Access Compliance Report

Public Rights-of-Way

Intersection ID: 13468	Main Street: W_PARK_AV	Cross Street: WICKFORD_PL	Location: NE
ADA ID: 9C2628D65627	Ramp Type: Perp	Initial Pass/Fail: Fail	Overall Compliance: No
Severity Score: 13.75			
Codes/Mitigation Info/Possible Solution		Field Measurements/Component Compliance

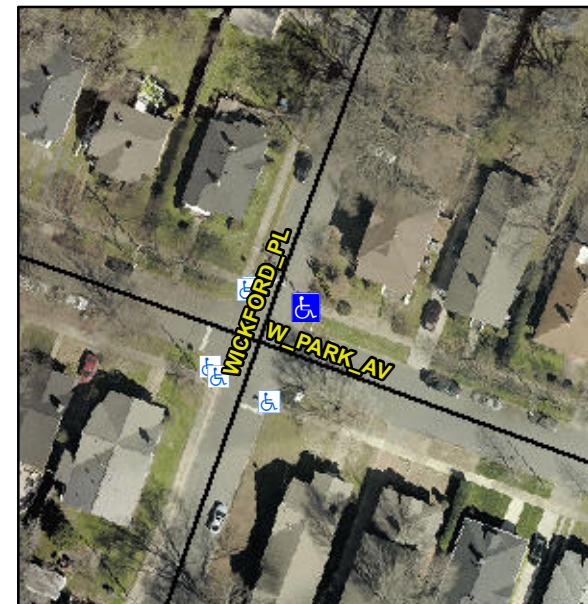
Not Found, R304.2.2, R304.5.3

Compliance	Description	Data	Compliance	Description	Data
N/A	Ramp Length (in)	57.0	No	Ramp Slope (%)	8.7
Yes	Ramp Width (in)	59.0	No	Ramp XSlope (%)	3.1
N/A	Flare Type LT	N/A	N/A	Flare Type RT	N/A
N/A	Flare Slope LT (%)	N/A	N/A	Flare Slope RT (%)	N/A
N/A	Flare Traversable LT?	N/A	N/A	Flare Traversable RT?	N/A
N/A	Landing Length (in)	N/A	N/A	DWS Provided?	N/A
N/A	Landing Width (in)	N/A	N/A	DWS Contrast?	N/A
N/A	Landing Slope (%)	N/A	N/A	DWS Length (in)	N/A
N/A	Landing X Slope (%)	N/A	N/A	DWS Full Width?	N/A
N/A	Landing Curb? (Y/N)	N/A	N/A	DWS Offset (in)	N/A
N/A	Shared Landing?	N/A			
N/A	Gutter Ponding?	N/A	N/A	Gutter Slope (%)	N/A
N/A	Gutter Lip Ht (in)	N/A	N/A	Gutter X Slope (%)	N/A
N/A	Painted X Walk1?	No	N/A	Painted X Walk2?	N/A
	X Walk 1 Direction	To NW		X Walk 2 Direction	N/A
N/A	X Walk 1 Width (in)	N/A	N/A	X Walk 2 Width (in)	N/A
	X Walk 1 Slope (%)	3.9		X Walk 2 Slope (%)	N/A
	X Walk 1 X Slope (%)	2.9		X Walk 2 X Slope (%)	N/A

Remove & Replace Entire Ramp.
